## OSSF Inspection Sheet

### **Permit of Authorization to Construct an On-Site Sewage Facility Permit Valid For One Year From Date Issued**

Re: Favorable Review of Nonstandard OSSF Design for:  
St. Jude's Ranch for Children Texas, Inc  
652 Old Bear Creek Road, New Braunfels, Comal County, Texas  
OSSF Permit Application Number OSSF- 118135

# ON-SITE SEWAGE FACILITY APPLICATION

**VOID**

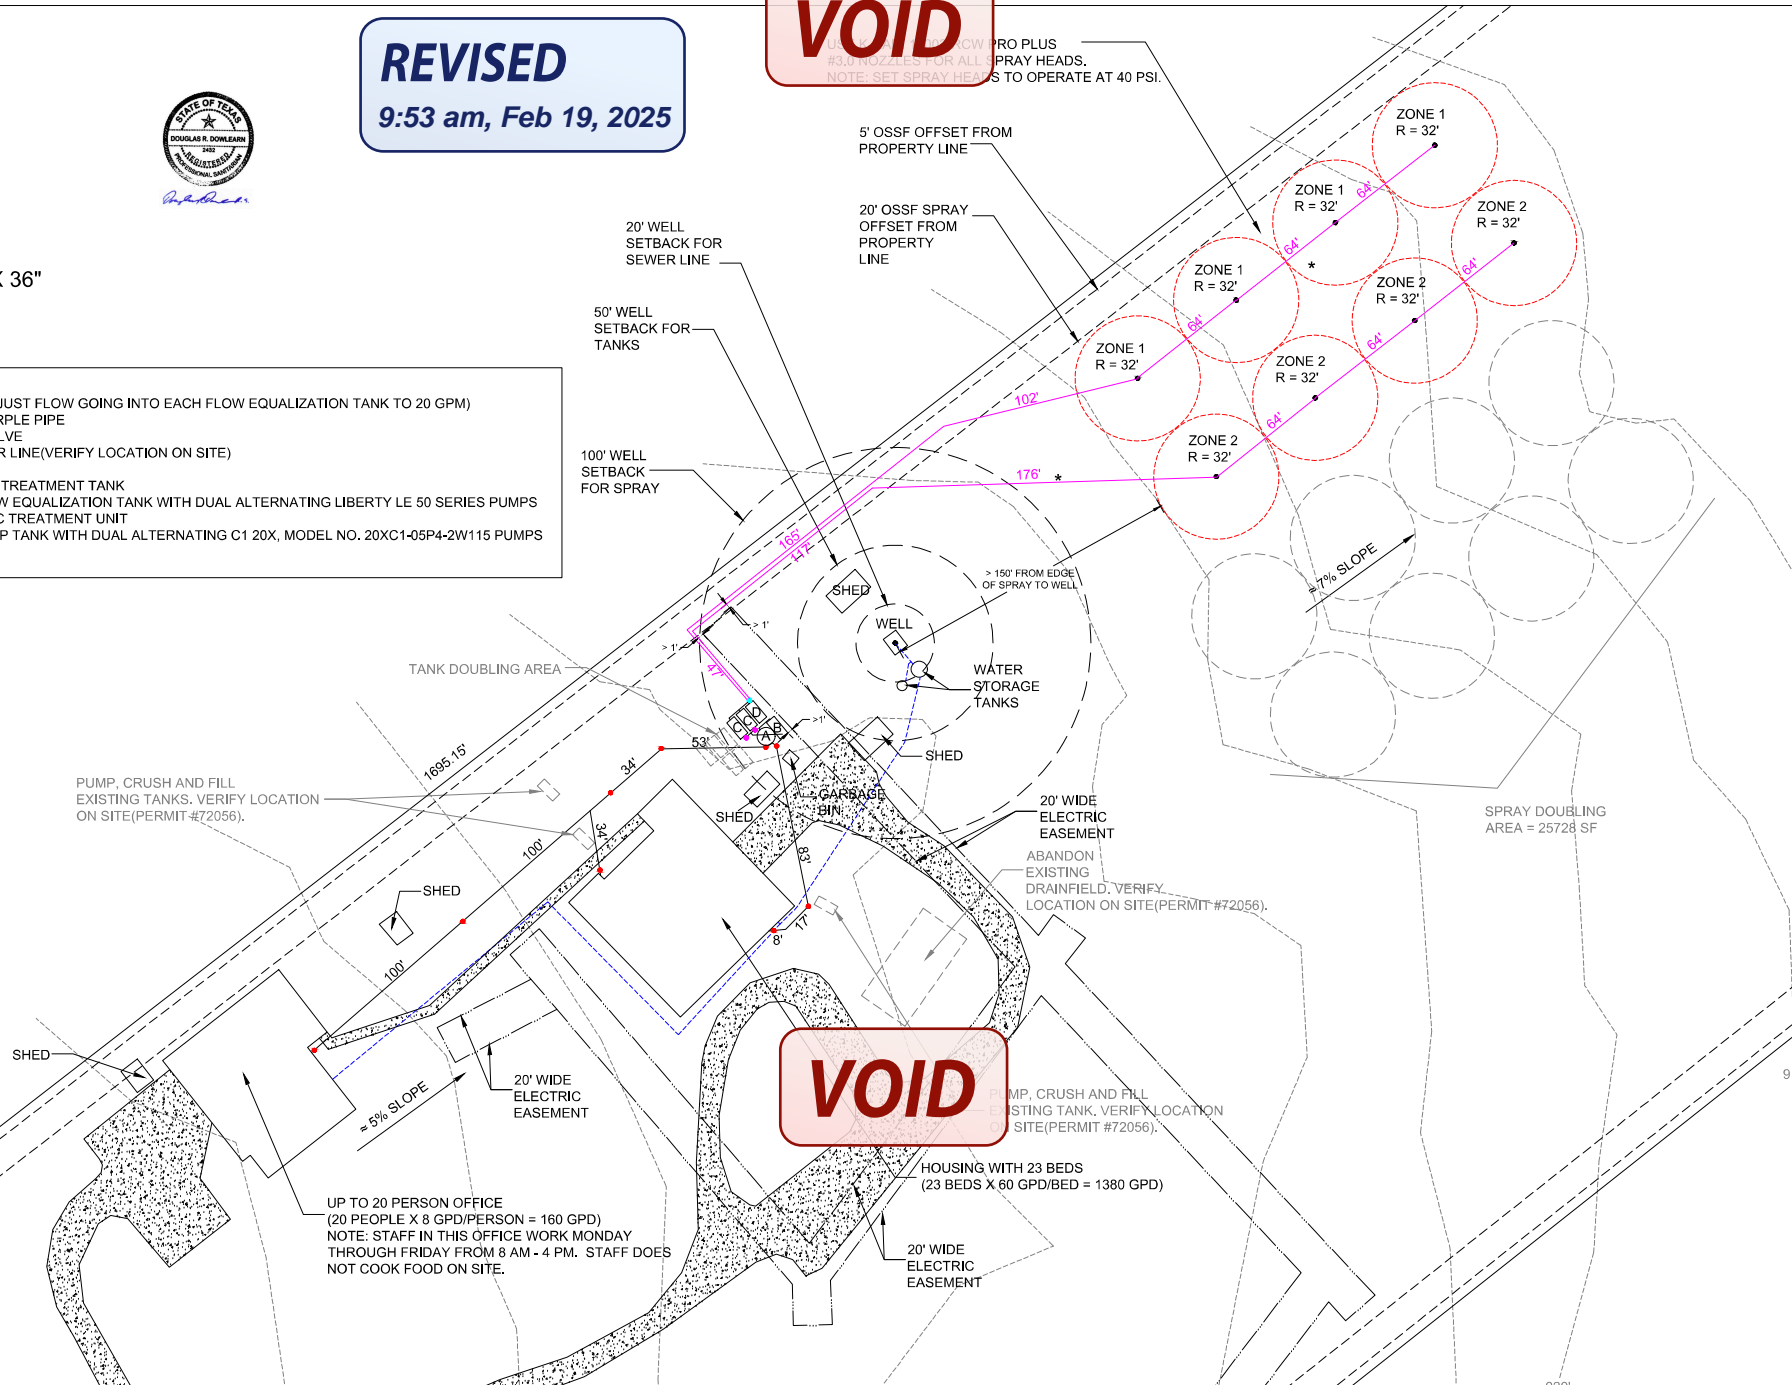
- - 2 WAY CLEANOUT
- - 2" BALL VALVE (ADJUST FLOW GOING INTO EACH FLOW EQUALIZATION TANK TO 20 GPM)
- - 1" SCH 40 PVC PURPLE PIPE
- - 2 ZONE K-RAIN VALVE
- - PROPOSED WATER LINE (VERIFY LOCATION ON SITE)
- \* - TEST HOLE
- A - 3000 GALLON PRE TREATMENT TANK
- B - 2000 GALLON FLOW EQUALIZATION TANK WITH DUAL ALTERNATING LIBERTY LE 50 SERIES PUMPS
- C - 1000 GPD AEROBIC TREATMENT UNIT
- D - 2000 GALLON PUMP TANK WITH DUAL ALTERNATING C1 20X, MODEL NO. 20XC1-05P4-2W115 PUMPS
- - DRIVE/WALKWAY

1.) 2" ball valves shall no longer be used to distribute flow evenly from the flow eq tank to the ATUS. Threaded caps with 5/8" drilled holes shall be placed on the end of the line going from the flow eq tank to each 1000 gpd ATU, which shall create equal flow into the ATUs. See update site plan and spec sheet.

- - 2 WAY CLEANOUT
- - THREADED CAP WITH 5/8" DRILLED HOLE ON END OF LINES GOING FROM FLOW EQ TANK TO ATUS TO CREATE EQUAL FLOW GOING INTO ATUS
- - 1" SCH 40 PVC PURPLE PIPE
- - 2 ZONE K-RAIN VALVE
- - PROPOSED WATER LINE (VERIFY LOCATION ON SITE)
- \* - TEST HOLE
- A - 3000 GALLON PRE TREATMENT TANK
- B - 2000 GALLON FLOW EQUALIZATION TANK WITH DUAL ALTERNATING LIBERTY LE 50 SERIES PUMPS
- C - 1000 GPD AEROBIC TREATMENT UNIT
- D - 2000 GALLON PUMP TANK WITH DUAL ALTERNATING C1 20X, MODEL NO. 20XC1-05P4-2W115 PUMPS
- - DRIVE/WALKWAY
